MFN-482-77

SUBJECT: SELECTION OF BWR/6 RELIEF VALVE CONTROL SYSTEM MODIFICATION

MARK III BWR/6 SRV CONTROL SYSTEM EVALUATIONS  
FOR SUBSEQUENT ACTUATION

# LOW-LOW SET RELIEF SOLUTION

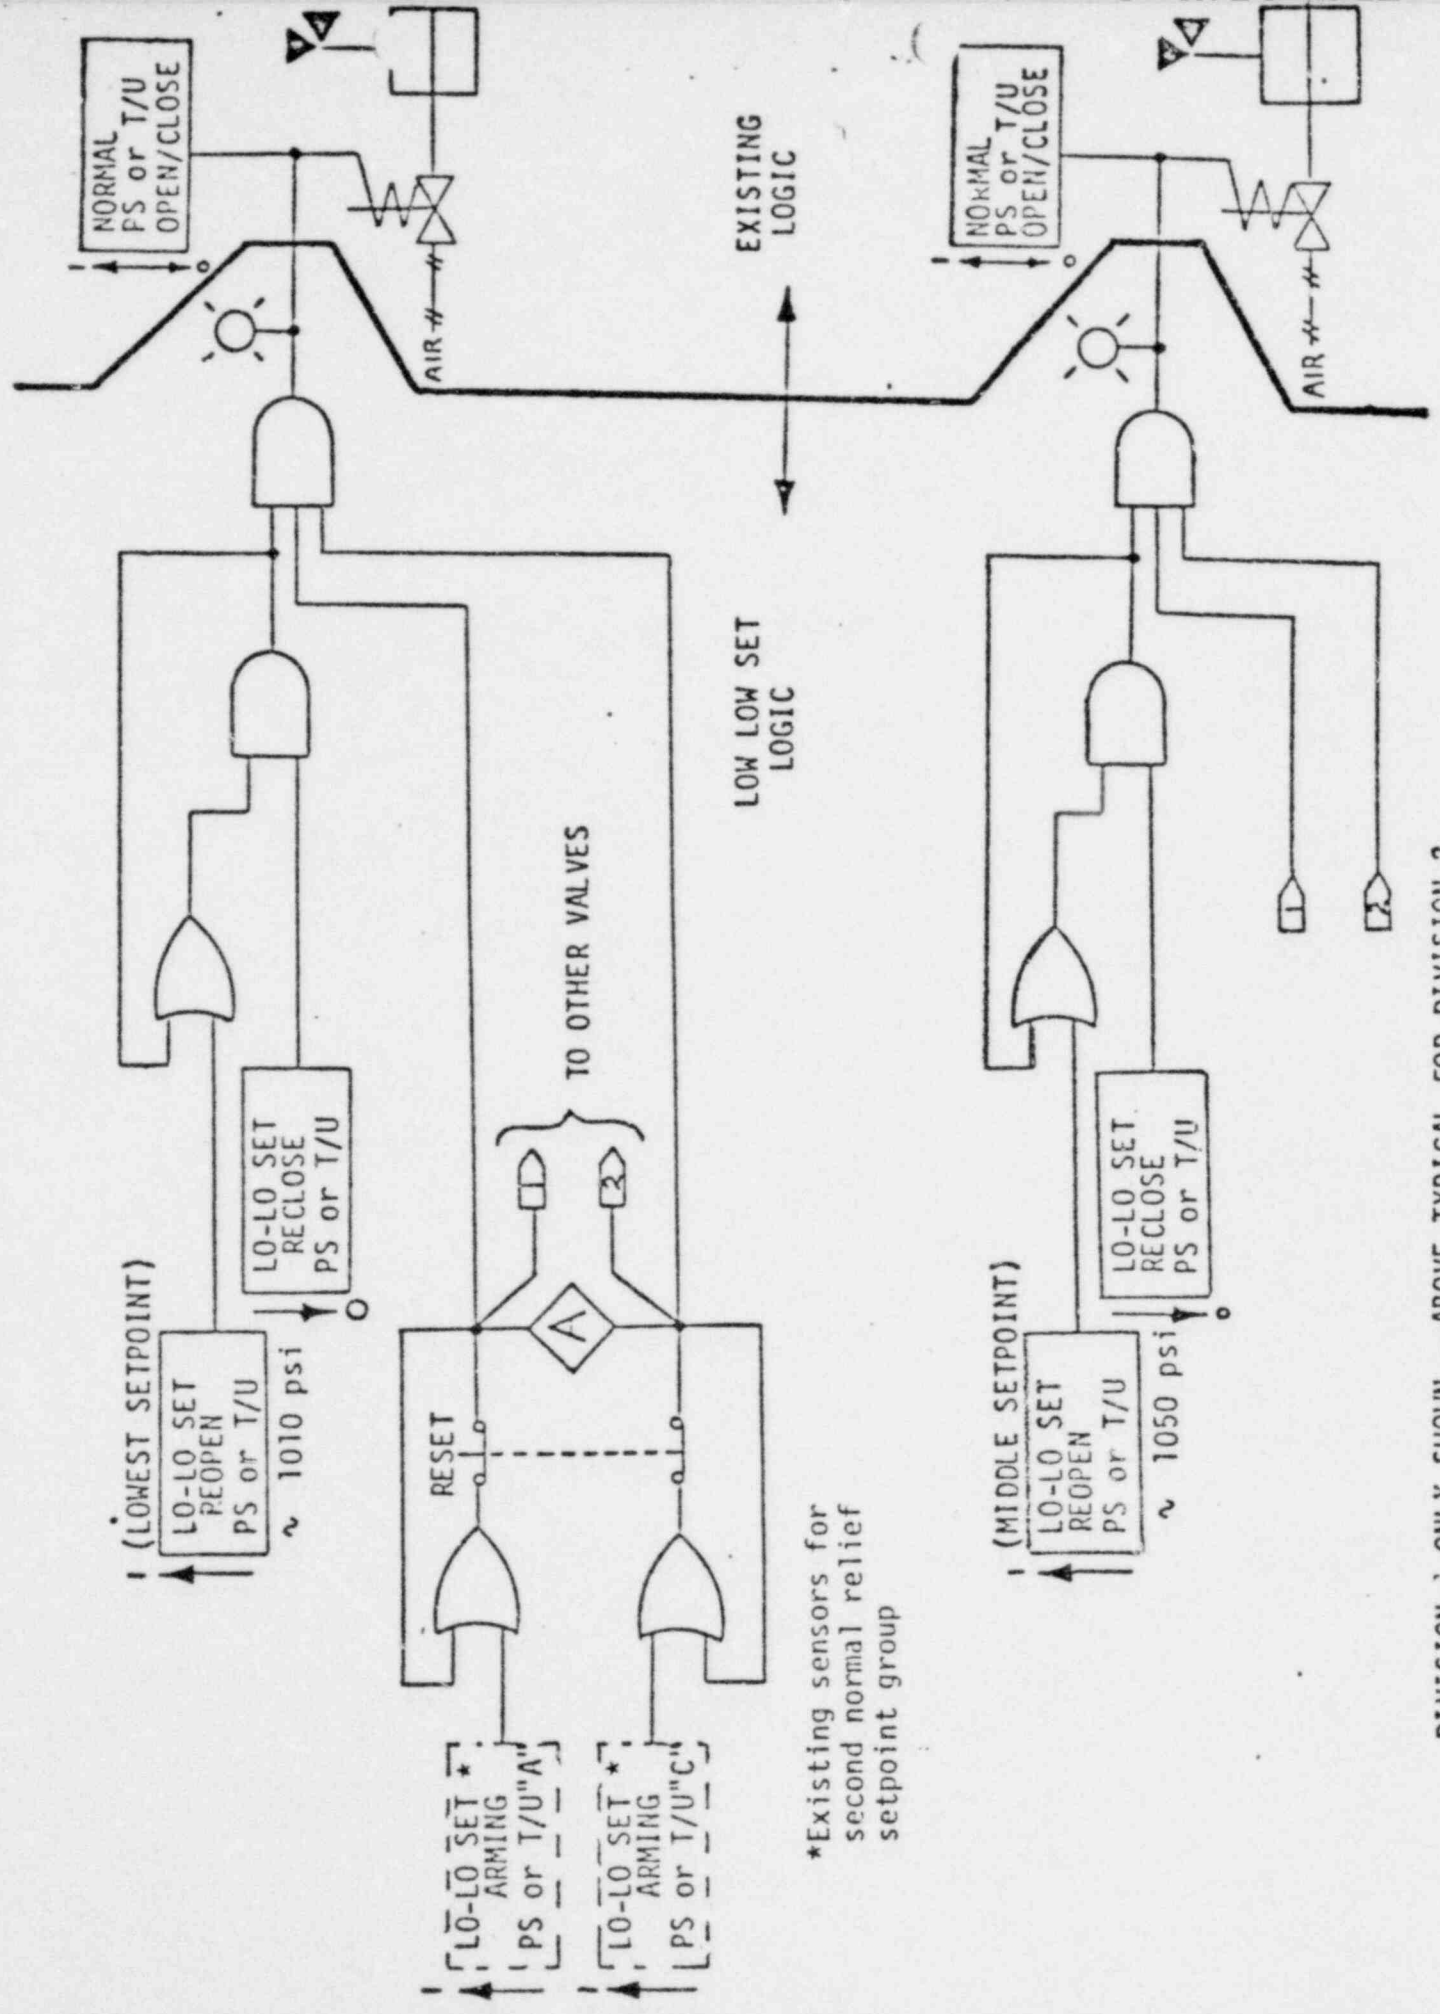
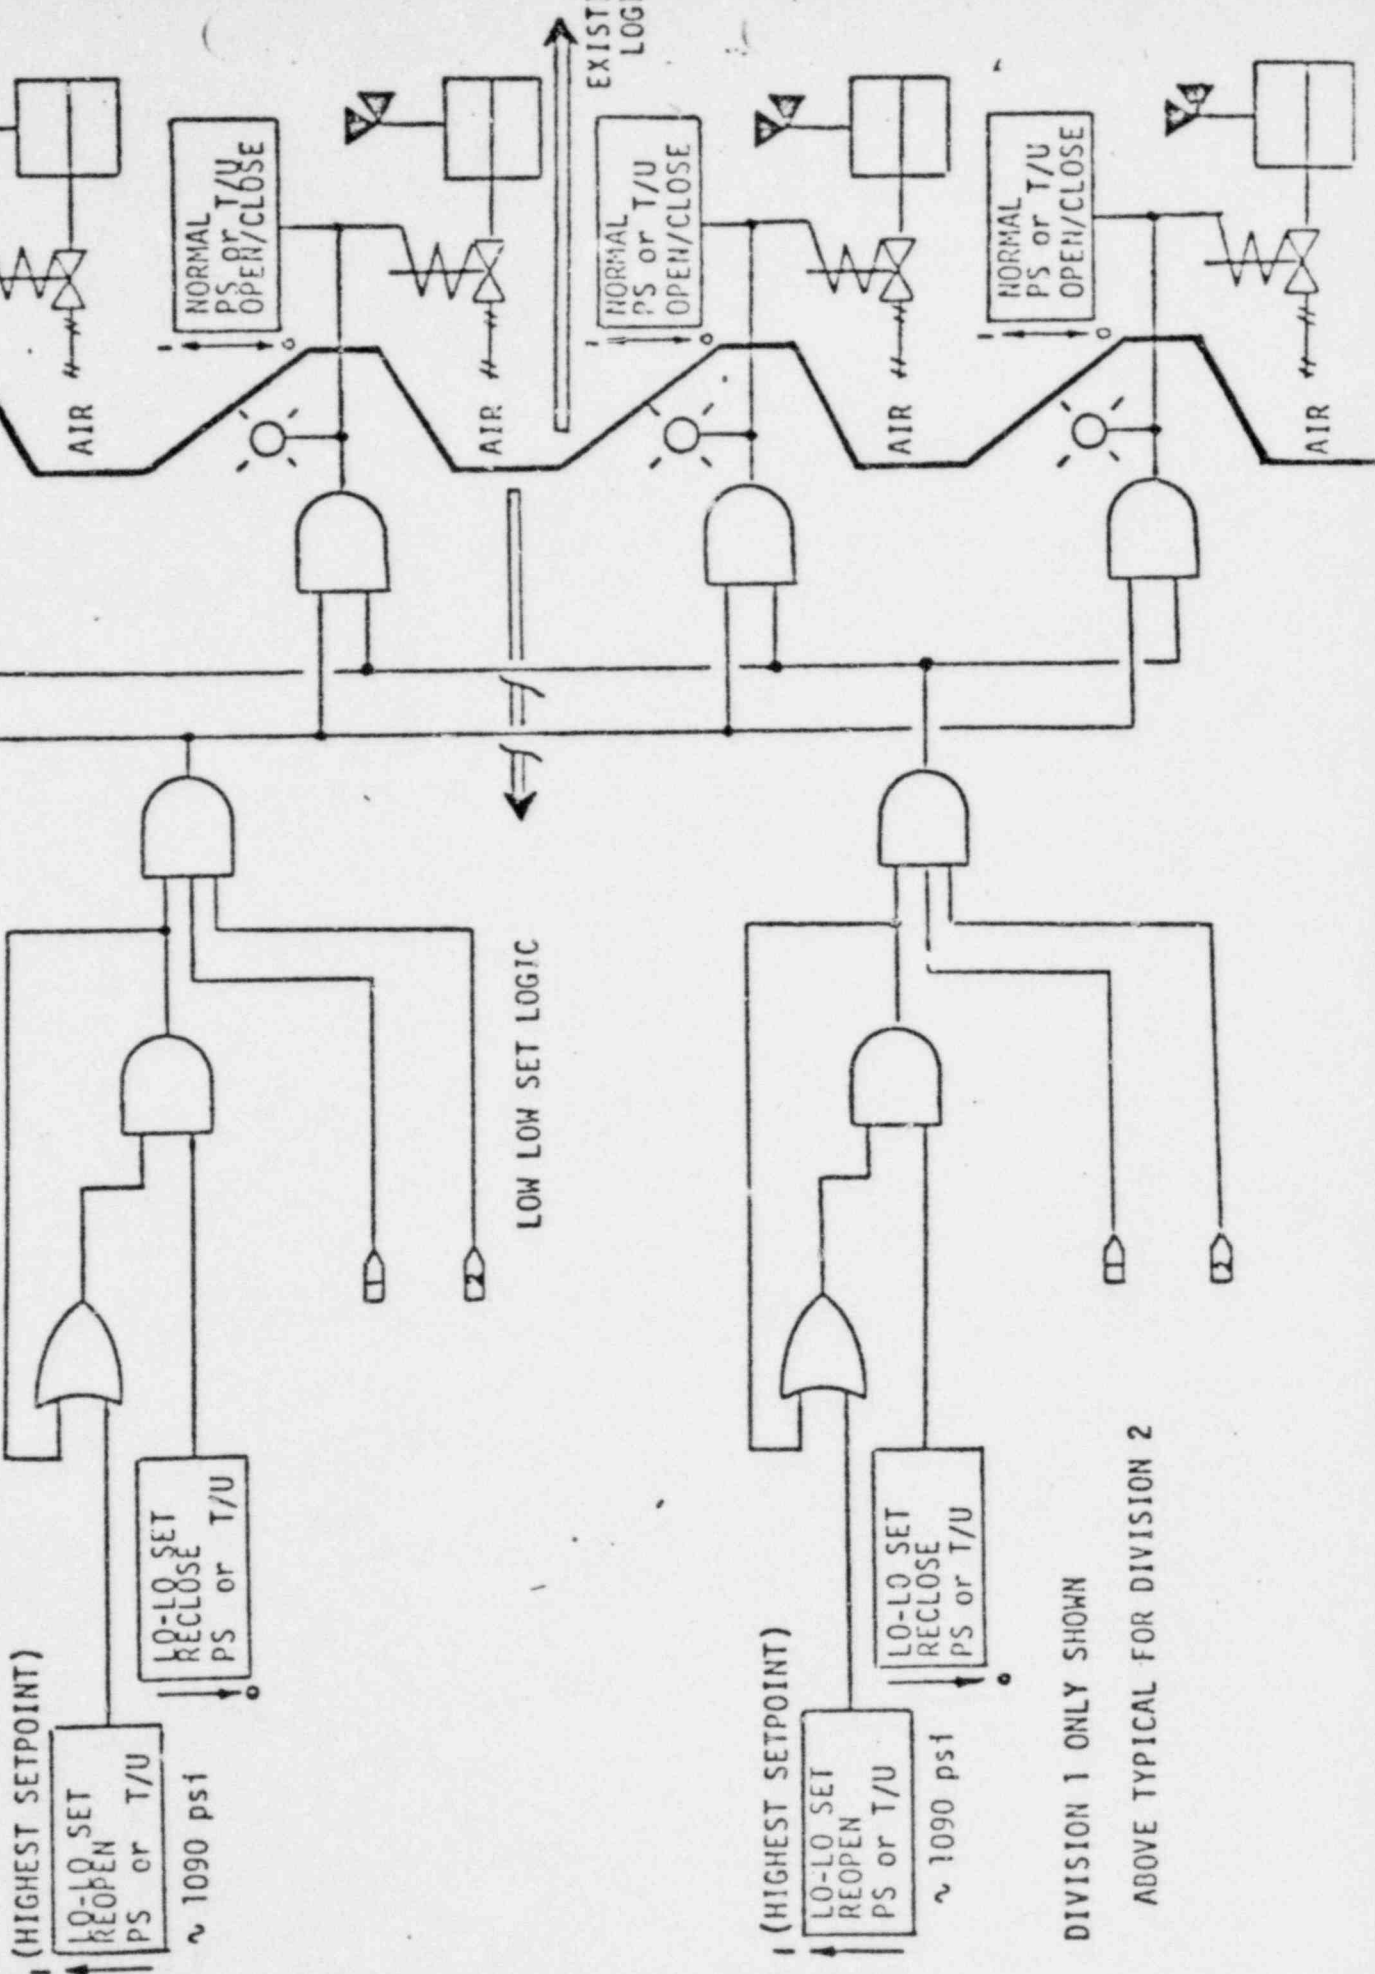
The low-low set relief logic system adds circuitry which imposes pre-established lower opening and closing set points for selected valves which override the normal setpoints following the initial opening of these valves. This logic is armed or activated by the existing pressure sensors of the second normal relief setpoint group. Once the transient has ended, the low setpoints can be disengaged by manual reset. A schematic logic diagram for the BWR/6 relief valve control system with the low-low set feature is attached. See Pages 3 and 4 of the attachment to this letter.

ADD INSTRUMENTS AND LOGIC WHICH WOULD SET DOWN BOTH THE OPENINGS AND CLOSING SET POINT OF SOME VALVES FOLLOWING THE INITIAL LIPT.

ARMED FROM - SRV OPENING FOR  
NORMAL RELIEF AND  
- REACTOR PRESS >  
NORMAL RELIEF
